From: "Robert Henwood" <rahplanning@bigpond.com>
Sent: Thu, 29 Jan 2026 17:12:12 +1000
To: "Maris-Claire Salazar" <maris-claire.salazar@townsville.qld.gov.au>
Cc: "Bruce Kingsun" <admin@kingsunproperties.com.au>; "Tony Parker" <tony@imcommercial.com.au>
Subject: RFI - 325 Shaw Road Shaw 4818 - Lot 19 SP107219
Attachments: 25-391 site plan - 28-01-2026.pdf, 01_TIA_Shaw.pdf, SK06-09_27.08.2025.pdf

Application no: MCU21/0089.03

Proposal: Change Other to Development Approval associated with MI16/0015

Street address: 325 Shaw Road SHAW QLD 4818

1 SITE PLAN
1 : 1000

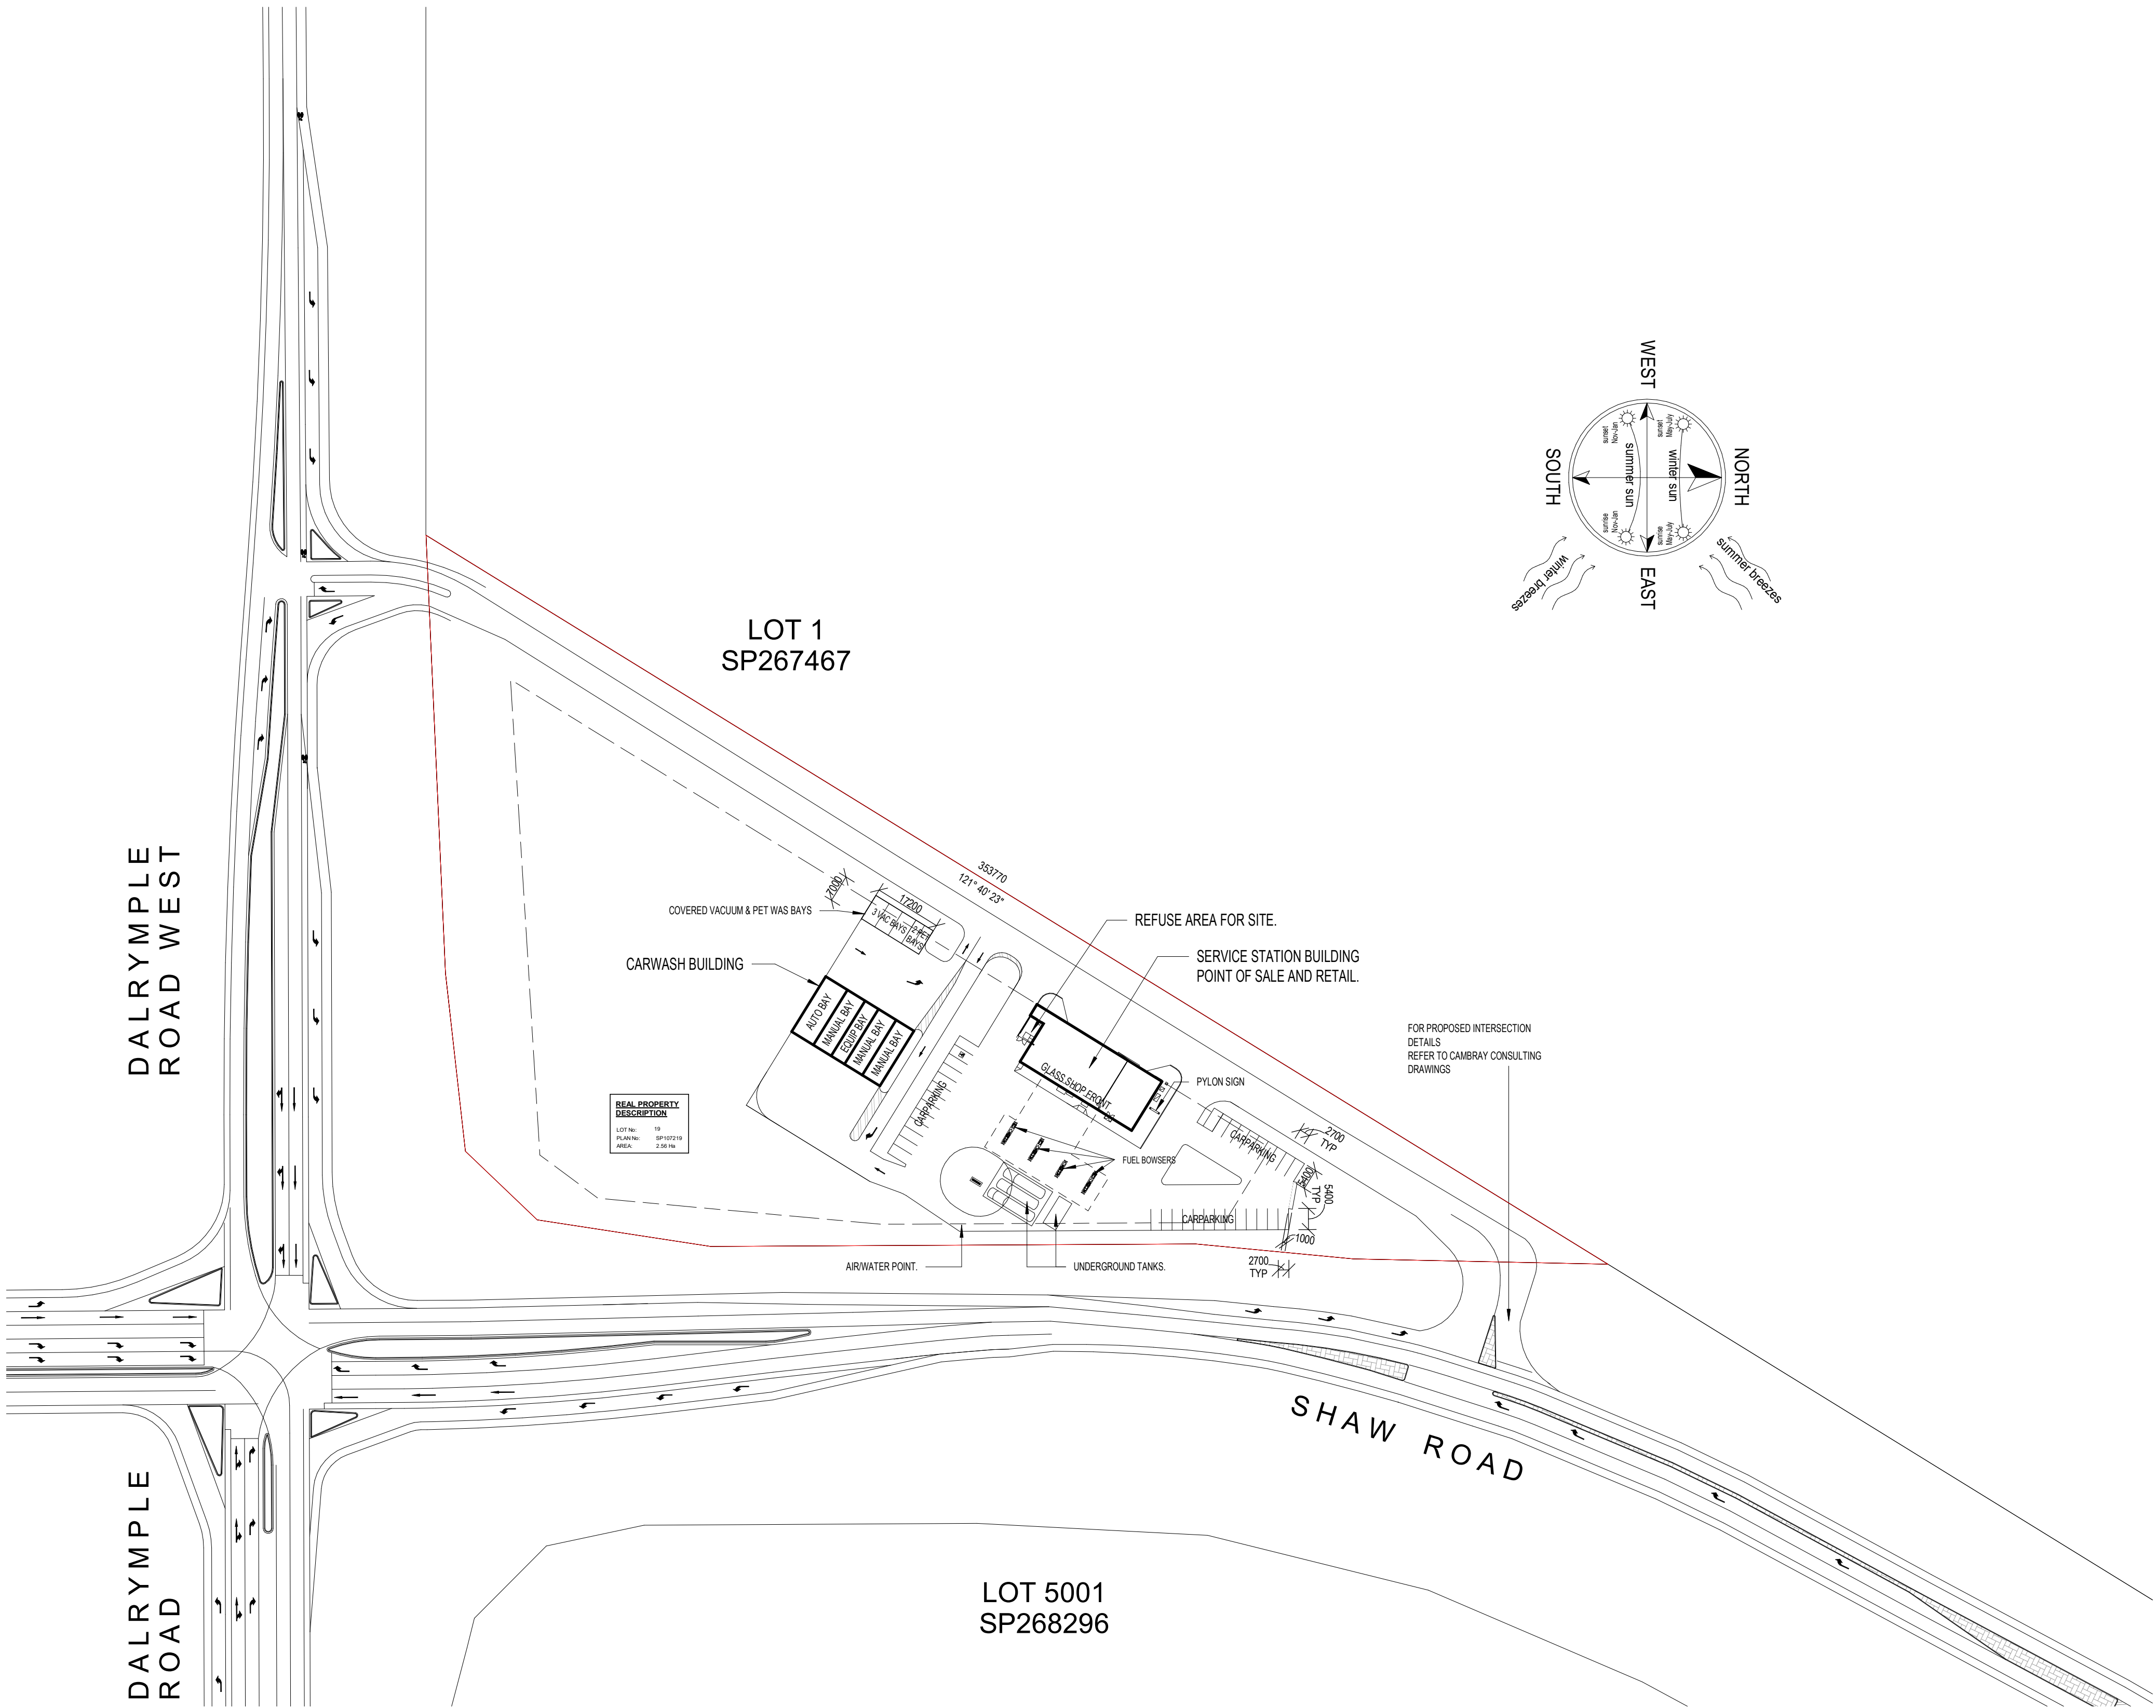
Request Item 1 – Amended Site Plan

The applicant is requested to provide an amended site plan to include the following:

- Detail of the proposed carwash layout, including appropriately notating vacuum bay(s), auto carwash bay(s) and carparking including dimensions.
- Detail of the proposed layout of the Service station, including appropriately notating all building and/or structures including but not limited to shop front(s), fuel bowers, underground/overground fuel tanks, pylon sign (if proposed), air/water point, refuse area, delivery area etc.
- A 1.0m end aisle widening as identified in Page 11 of the Traffic impact Assessment Report.

The requested amended sited plan is attached, it will be noted it provides

- *Details of the proposed car wash notating the vacuum bays*

- *Shows details of the service station layout including fuel bowser layout, underground tank locations, refuse location etc*
- *The location of the pylon sign*
- *The 1m aisle widening as required*
